COALPAC CONSOLIDATION PROJECT (10_0176)

ADDENDUM REPORT – 7 AUGUST 2013

PROPOSED CHANGES TO THE PROJECT

Figure 2: Mining Void 205

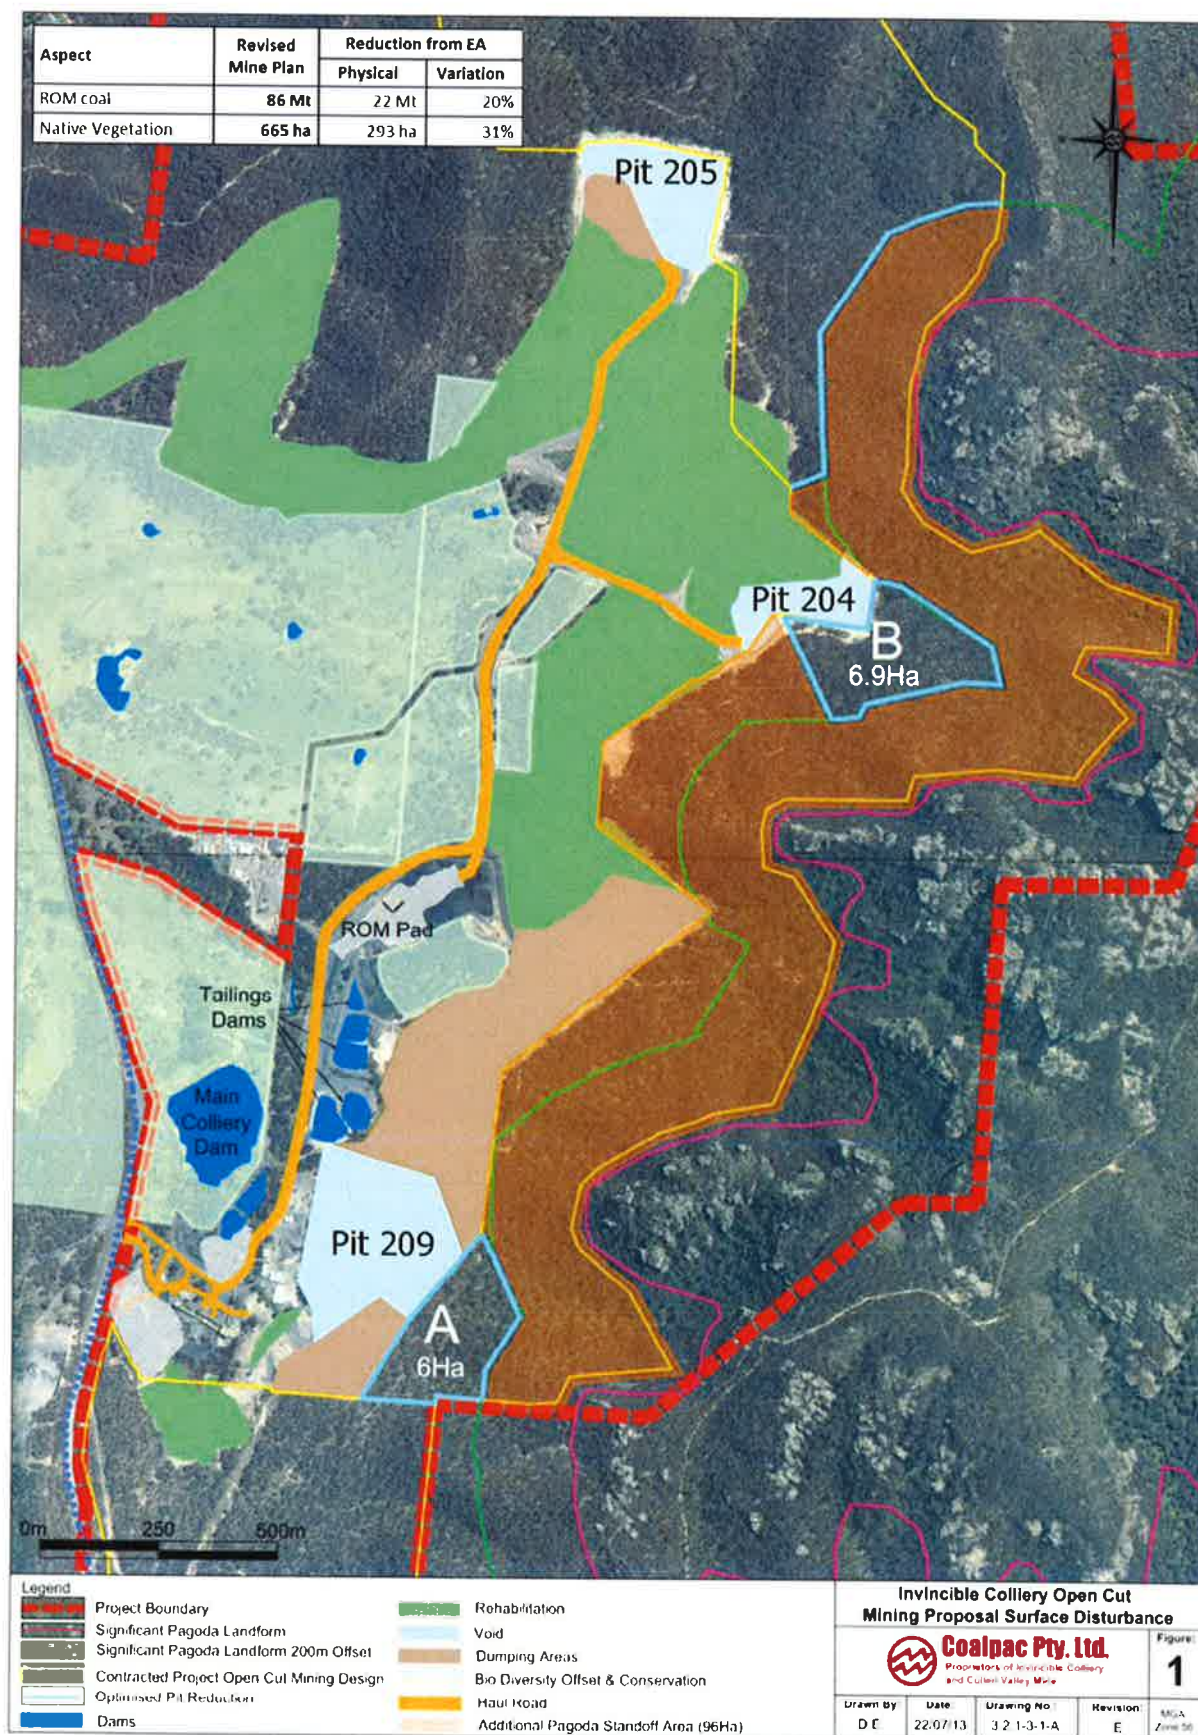
As can be seen from Figure 1, the proposed changes remove the majority of the proposed open cut mining in the proximity of the more significant pagoda formations within the project area. The exception is two areas covering 12.9 hectares adjacent to existing open cut mining pits where high quality coal would be recovered and overburden used to fill and rehabilitate the three existing mining voids on the site (see Figure 2 and Area "A" and "B" on Figure 3).

Figure 4: Proposed Additional Biodiversity Offsets

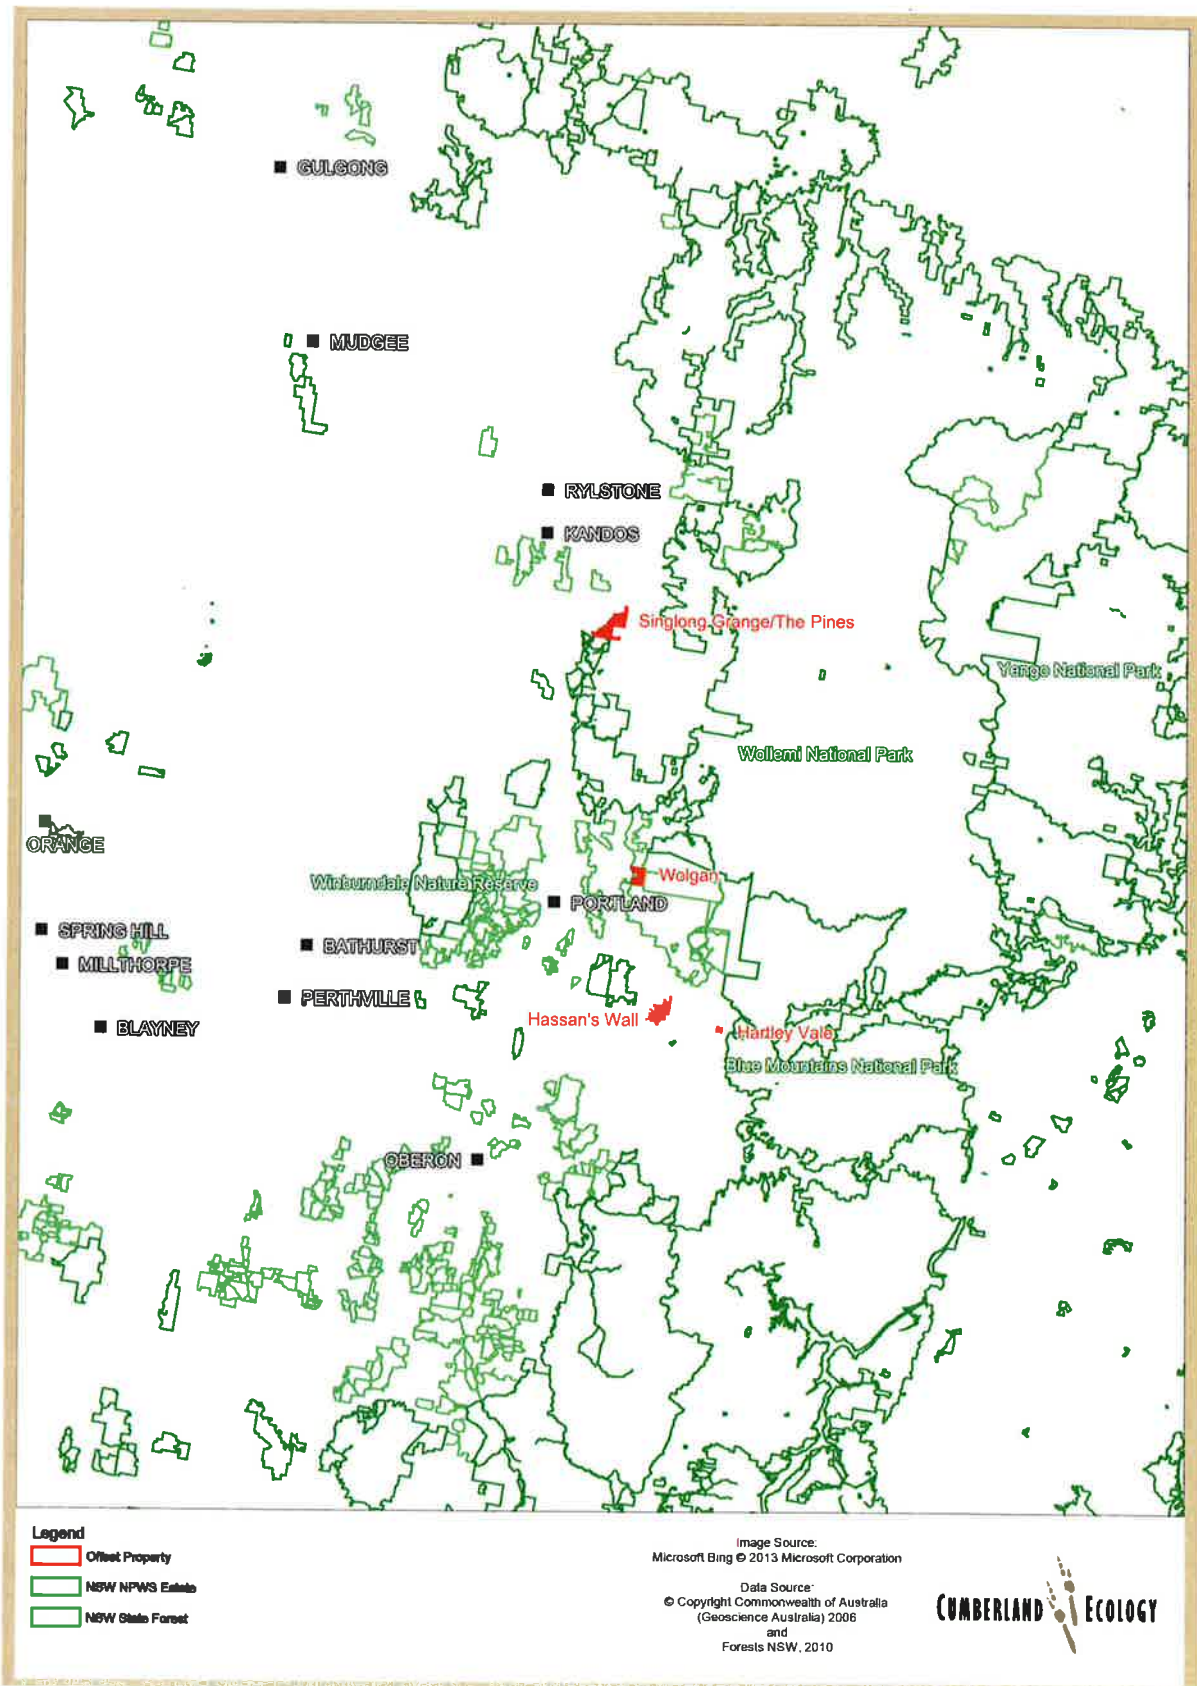
In its most recent submission, Coalpac has identified 4 additional offset properties that would deliver approximately 2,000 ha of remnant native vegetation (see Figure 4):

- Hartley Vale – 77 ha;
- Wolgan – 483 ha;
- Hassan's Wall – 697 ha; and
- Singlong Grange – 744 ha.

Consequently, if all 8 of the proposed offset areas are secured, the strategy would deliver in excess of 4,000 ha of remnant native vegetation (i.e. equivalent to an offset ratio of around 6:1).

Based on the information recently provided by Coalpac, it appears that the additional offset properties comprise good quality remnant native vegetation, and in the case of the Hassans Wall area, significant sandstone escarpments and possibly pagoda rock formations. The Department also notes that the additional offsets focus on strengthening the 'like for like' compensation for particular vegetation communities which is supported by the Department. However, the Department notes that two of the potential offset areas are already in public ownership (i.e. Hassan's Wall and Wolgan Gap). Consequently, while the areas may hold important biodiversity and geodiversity values worth conserving, the Department does not see how protecting these areas would significantly improve biodiversity or geodiversity values in the area, and hence compensate for the loss of these values on the site as a result of mining.

Figure 5: Contracted Mining Area
 [Note that recent changes to mine plan only apply within the inset, and other parts of the mine plan remain unaltered]

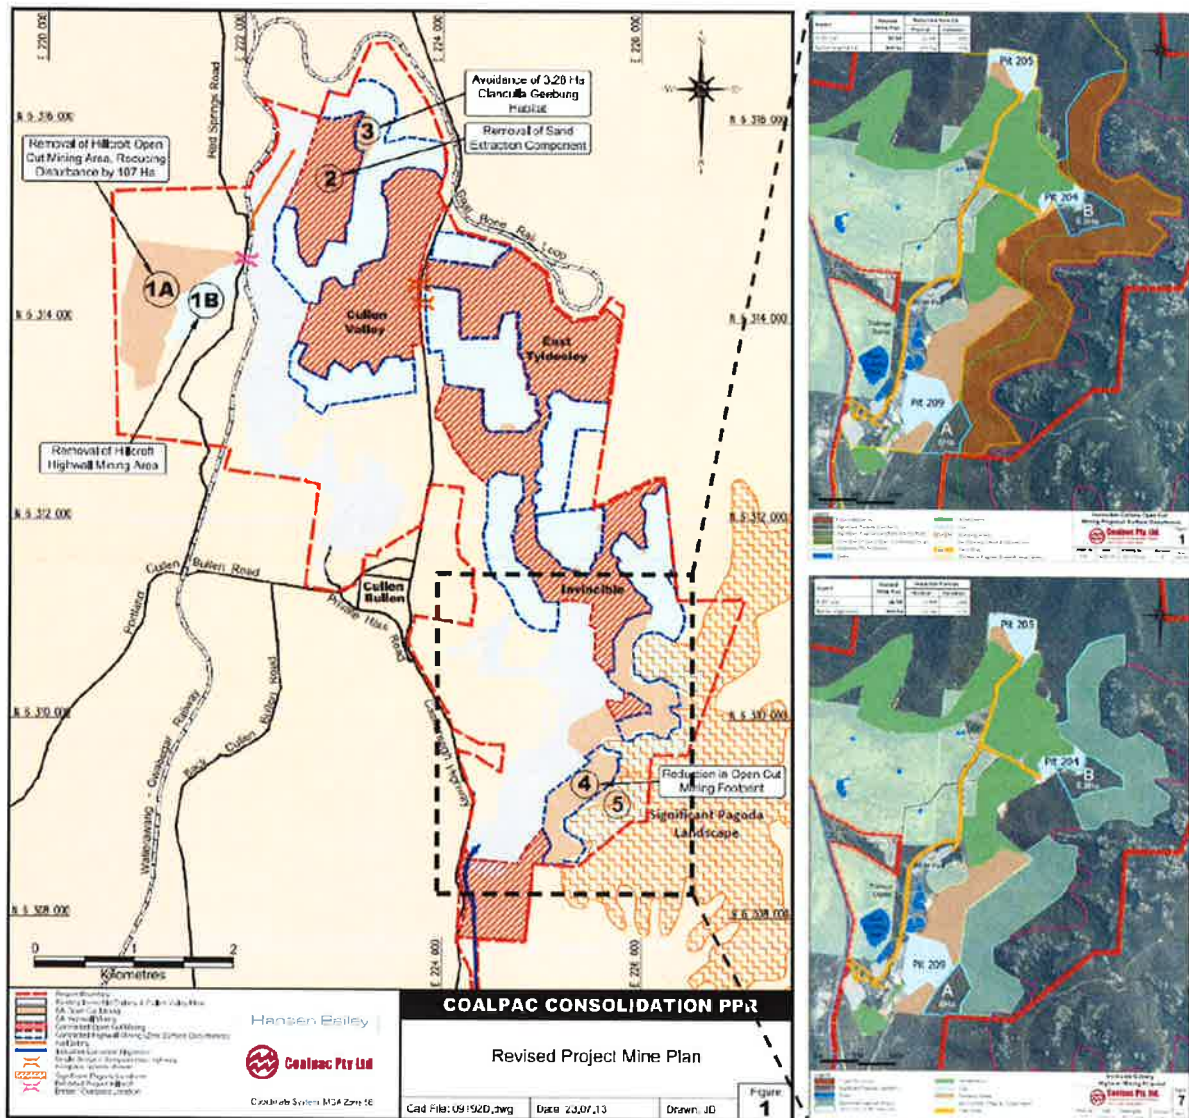
- retaining a greater proportion of the native woodland on the slopes below some of the most significant pagoda formations in the project area;
- reducing the biodiversity impacts of the project and the impacts on the scenic values of a proportion of the pagodas adjacent to the active mining areas; and
- allowing the existing open cut mining voids at Invincible Colliery to be filled, capped and appropriately rehabilitated (see Pits 204, 205 and 209 in Figure 5 below).

The Department supports the proposed changes, and believes that they go some way towards reducing the overall impacts of the project on biodiversity and the pagoda landform complex. However, the proposed changes do not alter the bulk of the proposed mine plan to the north of Invincible and on the western side of the Castlereagh Highway to the north of Cullen Bullen. This can be seen in Figure 5 which illustrates how the proposed changes to the mine plan are confined to a small portion of the total open cut and highwall mining area.

Figure 6: Revised Open Cut Mining Footprint

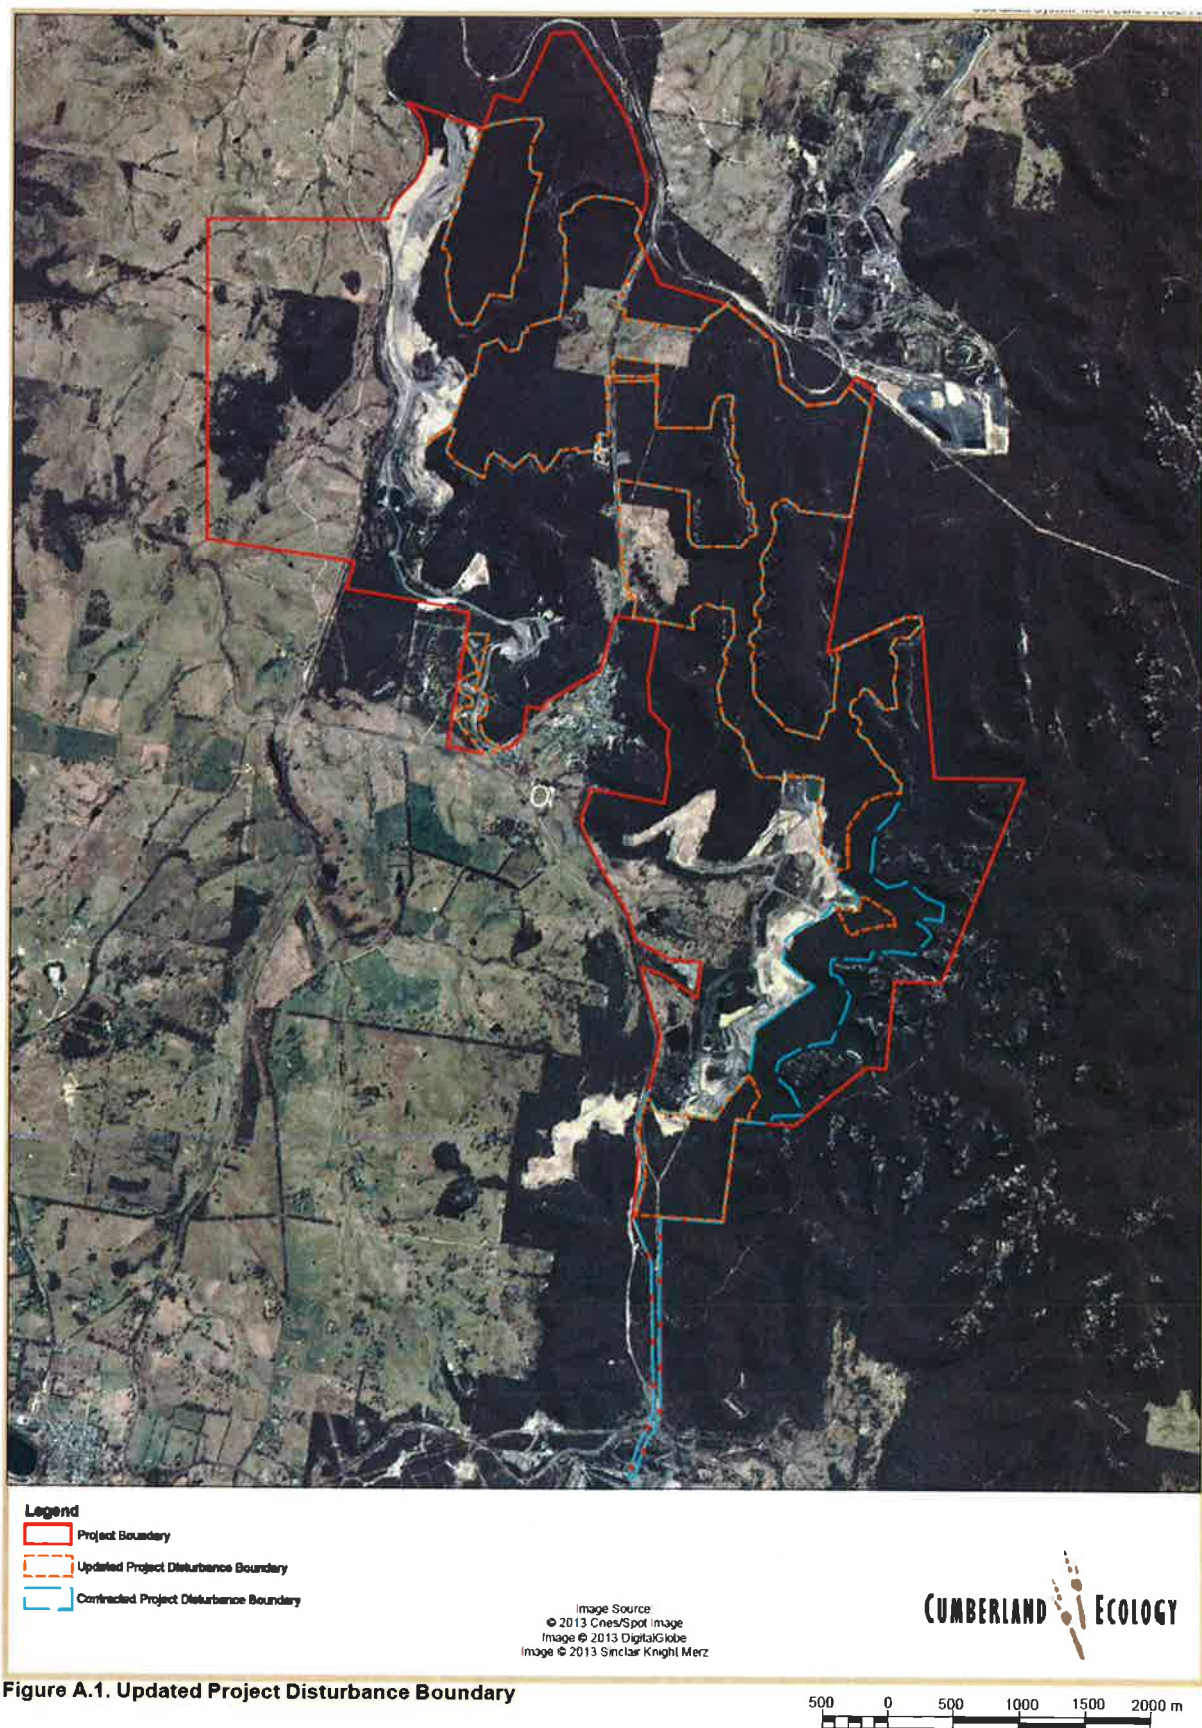
Based on the information provided by Coalpac in its Preferred Project Report, the Department is confident that the structural integrity of the pagodas could be maintained if the mine were to proceed. However, protecting the pagodas from structural damage does not preserve the pagoda landform complex, and the revised project would almost completely remove the slopes and valleys beneath the pagoda formations over a large area (see Figure 6). In so doing, the biodiversity, scenic and geo-heritage values of the area that have been identified by the Planning Assessment Commission as internationally significant would essentially be destroyed.

In this case, the risks to successful rehabilitation are increased due to the relatively steep slopes that would need to be rehabilitated along the edges of the proposed open cut mining area to properly integrate with the slopes below the pagoda formations. Furthermore, even though the active mining areas would be progressively rehabilitated, the proposed mine life is 21 years, and it would take 50 to 100 years for the biodiversity and landscape values of the site to recover assuming that the rehabilitation is broadly successful. This highlights the inherent uncertainty associated with mine site rehabilitation, and the fact that rehabilitation is unlikely to ever be able to replicate the biodiversity and landscape values that would be lost if the mine proceeds.
